Reference no.: SDA_86416

Service information

Low milk temperature in Xelsis, Exprelia and Gaggia Accademia

Image 3

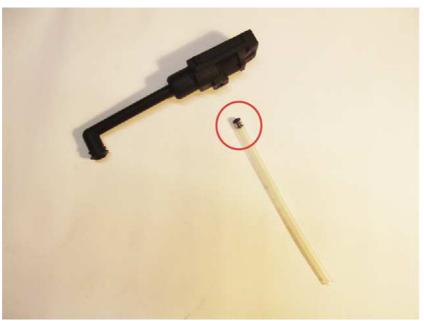
Ornplaint of low temperature of milk beverages in Xelsis, Exprelia and Gaggia Accademia. Modification implemented in production in week 09 / 2011.

CURE: Replace the black milk tube connector by the white one, part code 11026779, in order to increase the milk temperature by 2-4

degrees.

Replace the connector shown in the image 3.
